Technical Memorandum

Date: April 23, 2014

Re: **Addendum No. 1 - Emergency Action Work Plan for Areas G-1B and G-3 Supplemental Soil Investigation – Area G-1B Emergency Action SD8 Area North Marina Ameron/Hulbert Site, Everett, Washington**

Figure 1 Supplemental Soil Investigation Area

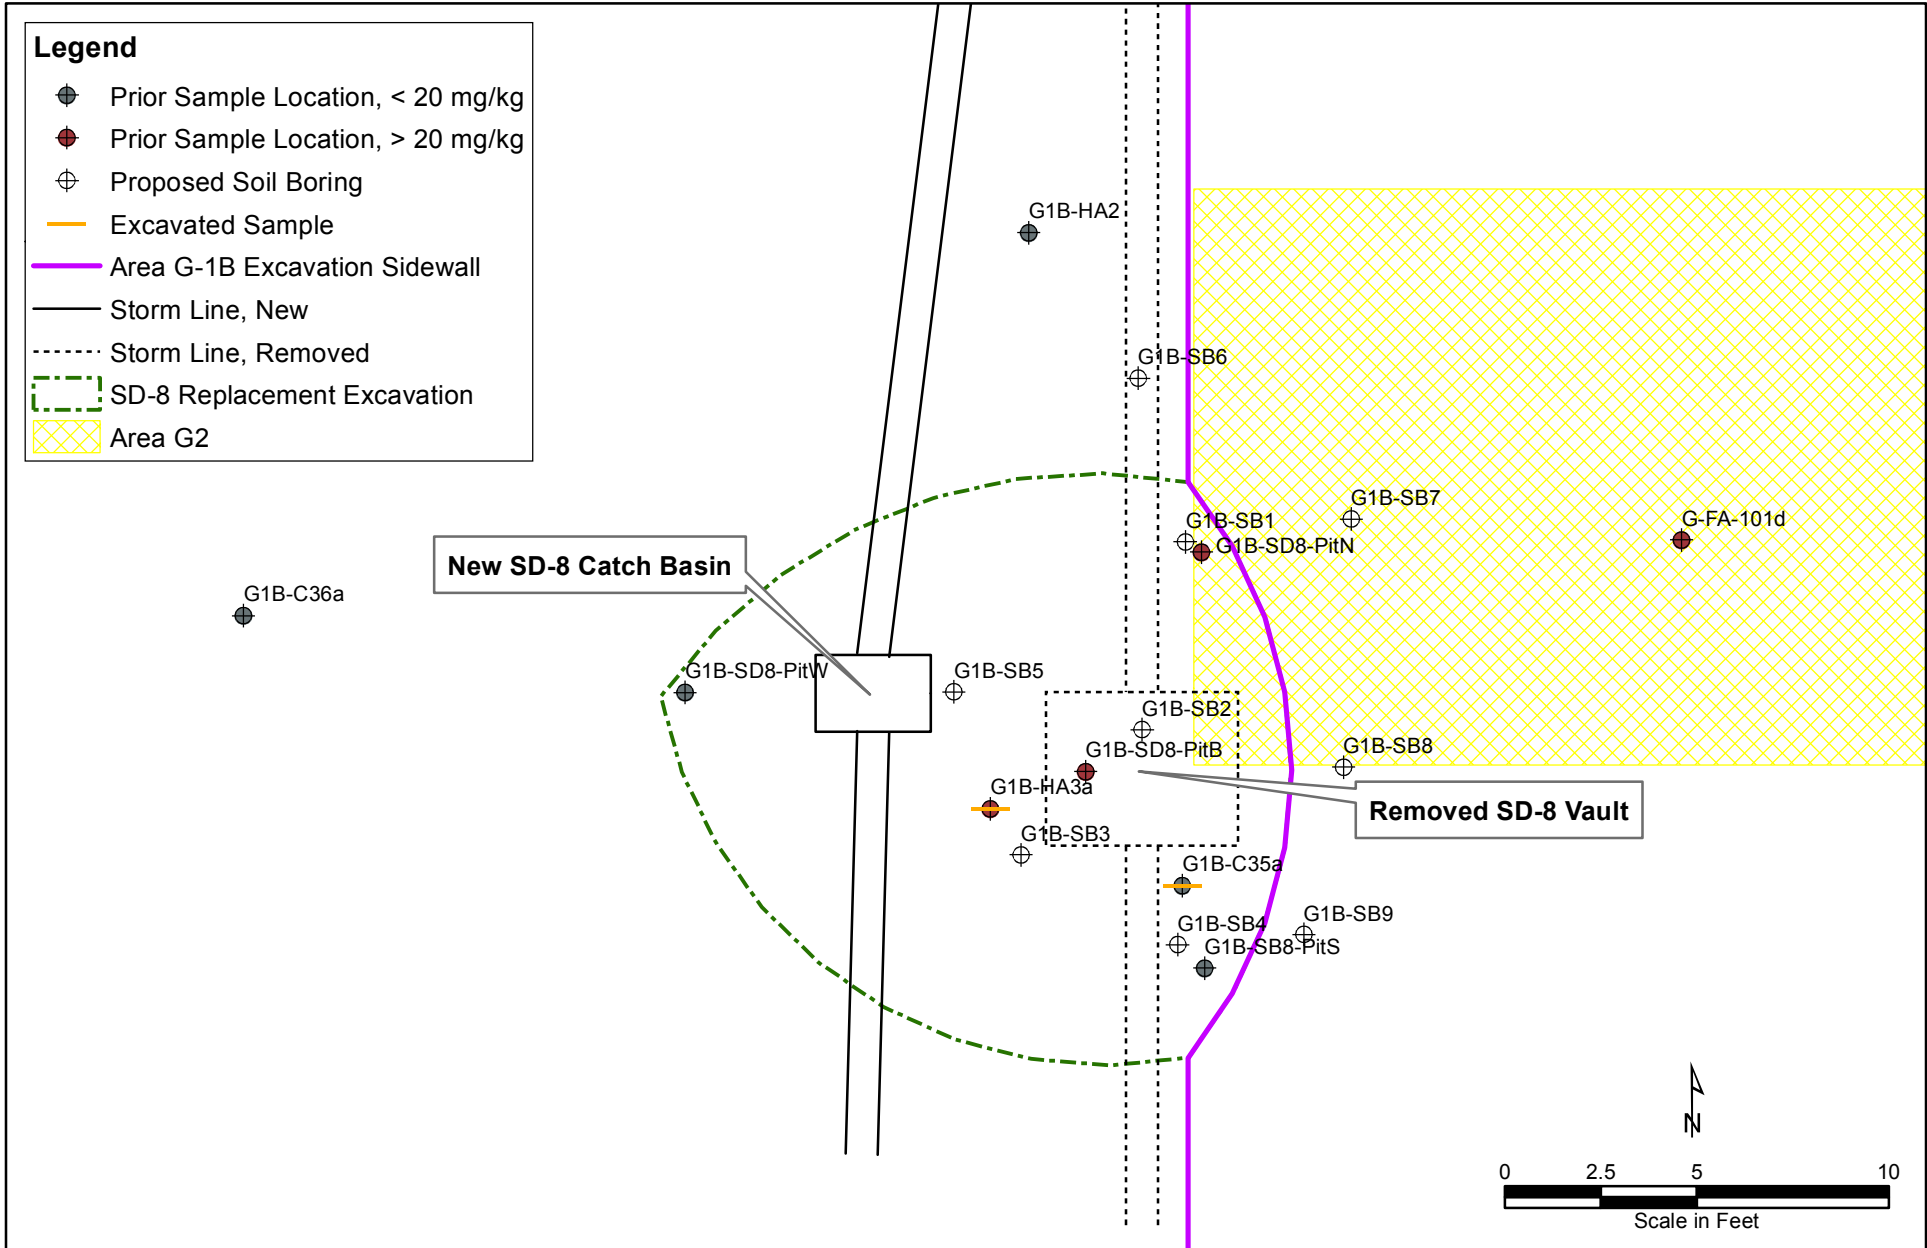
The proposed scope of work will delineate the extent of arsenic contamination underlying and around the former SD8 catch basin. The field procedures, analytical methods, and quality assurance/quality control (QA/QC) procedures will be consistent with those presented in the

Additional soil investigation in the vicinity of the former SD8 will include the following:
